Access Compliance Report

Public Rights-of-Way

(Curb Ramps)

Intersection ID: 2475	Main Street: HIGHLAND_CREEK_PY	Cross Street: WILDBROOK_DR	Location: W
ADA ID: 3CD8F8E87189	Ramp Type: PerpDiag	Initial Pass/Fail: Fail	Overall Compliance: No
			Severity Score: 21.25

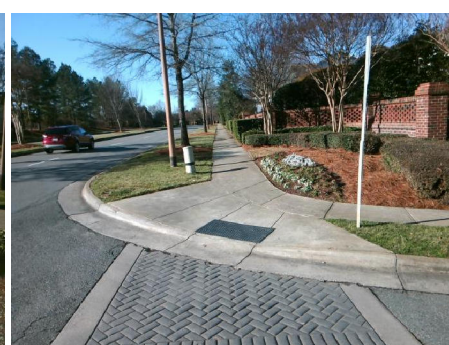
Codes/Mitigation Info/Possible Solution			Field Measurements/Component Compliance		
	Possible Solutions:		Compliance	Description	Data
	Remove & Replace Curb Ramp With Two New Directional Ramps or Equivalent.		Yes	Ramp Length (in)	60.0
			No	Ramp Width (in)	36.5
			N/A	Flare Type LT	N/A
			N/A	Flare Slope LT (%)	N/A
			N/A	Flare Traversable LT?	N/A
			N/A	Landing Length (in)	N/A
			N/A	Landing Width (in)	N/A
			N/A	Landing Slope (%)	N/A
			N/A	Landing X Slope (%)	N/A
			N/A	Landing Curb? (Y/N)	N/A
			N/A	Shared Landing?	N/A
			N/A	Gutter Ponding?	N/A
			N/A	Gutter Lip Ht (in)	N/A
			No	Painted X Walk1?	N/A
				X Walk 1 Direction	To SE
			N/A	X Walk 1 Width (in)	N/A
				X Walk 1 Slope (%)	2.9
				X Walk 1 X Slope (%)	1.4
			N/A	Ramp inside XWalk1?	N/A
Surveyor Notes: N/A PROW/ADA: Not Found, R304.5.1, R304.5.3			N/A	Flare Type RT	N/A
			N/A	Flare Slope RT (%)	N/A
			N/A	Flare Traversable RT?	N/A
			N/A	DWS Provided?	N/A

N/A	DWS Contrast?	N/A
			N/A	DWS Length (in)	N/A
			N/A	DWS Full Width?	N/A
			N/A	DWS Offset (in)	N/A
			N/A	Gutter Slope (%)	N/A
			N/A	Gutter X Slope (%)	N/A
			No	Painted X Walk2?	N/A
				X Walk 2 Direction	To E
			N/A	X Walk 2 Width (in)	N/A
				X Walk 2 Slope (%)	0.4
				X Walk 2 X Slope (%)	2.9
			N/A	Ramp inside XWalk2?	N/A
			N/A	Clear Space?	N/A
			N/A	Clear Space to XWalk (in)	N/A
			N/A	Storm Grate/Utility Hazard?	N/A
				Storm Grate/Utility Type	N/A
			N/A		N/A
			Yes	Surface Condition? (G/P)	Good
Total Cost:		\$ 3200.00
